Service Information

Engine platform: M32 Engine section: Exhaust gas Engine type: M 32E/ M34 DF Validity: until further notice

No. 0011M32 • Issue 1; February 27, 2020

Exhaust gas cladding M32 E/ M34 DF

Sketch 1

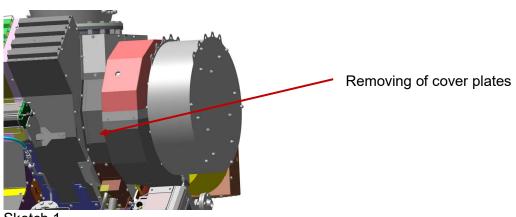
Step 1: Removal of cover plates per sketch 1 and 2

To avoid damages to the turbine housing and bolts, we therefore recommend removing these two plates of the exhaust cladding.

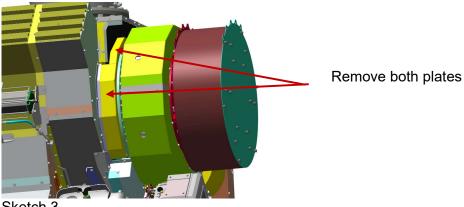
If necessary: removal of upper cover

Sketch 5

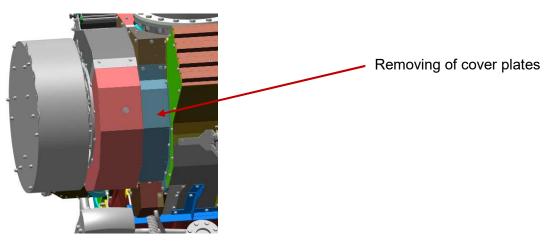
Step 1: Removal of cover plates per sketch 5 and 6

Sketch 6

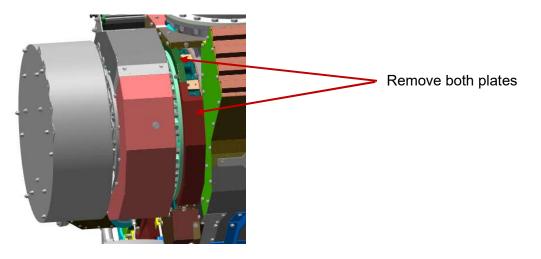
If necessary: removal of upper
